APPLICATION: DA2020/1376

PROPERTY: 38 Carrington Parade, Curl Curl

PROPOSAL: Alterations and additions to a dwelling house

Figure 1: View from balcony of my client's property towards subject site and Curl Curl Beach

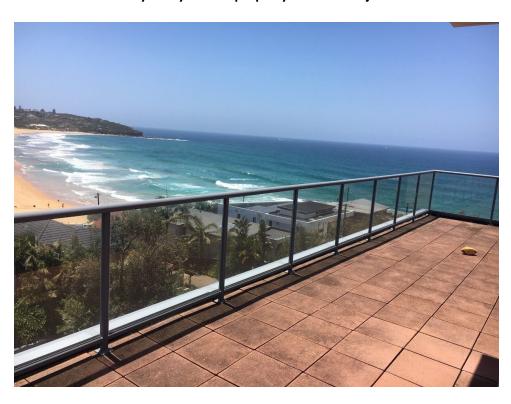
Part D7 of Warringah Development Control Plan requires that the design of any development be considered to minimise the loss of views from neighbouring properties. My client's property enjoys significant water views to the north-east towards Curl Curl Beach (refer to Figures 1 & 2).

The submitted development application does not include an assessment on the impact of the development on views from uphill properties, and it is therefore difficult to ascertain the impact of the development on the views currently enjoyed from my client's private open space area.

We therefore request that the bulk and scale of the development be reduced to fully comply with Council's controls. In addition, we request that an indicative photomontage or height poles be provided by the applicant to demonstrate the impact on my client's views.
